Solution for EMI

Model name : WTN-17WE2

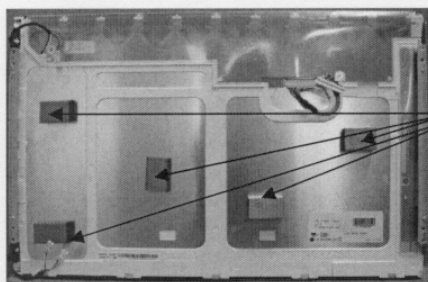
1. Attachment a gasket on the LCD module. (see the picture below)

5 gaskets on the back side of panel.

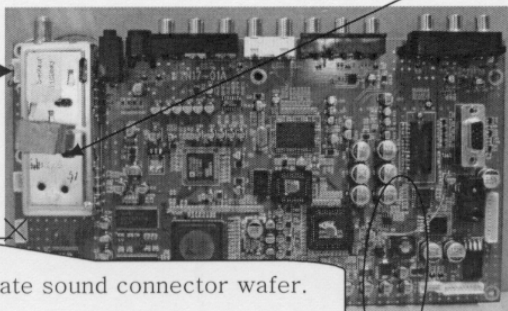
2. Attachment a gasket on the tuner. (see the picture below)

1 gasket on the tuner.

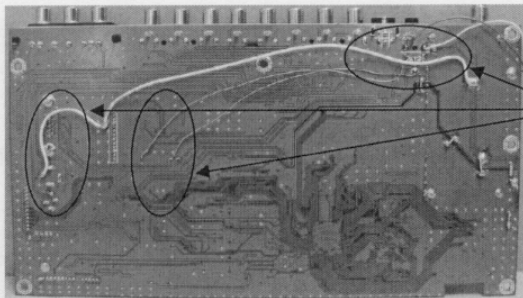
Relocate sound connector wafer.

3. Relocate the connector wafer which outputs TV sound and its additional works.

The wires will be modified with PCB pattern artwork.

(see the picture above and below)

Relocate sound connector wafer
and its additional wiring work
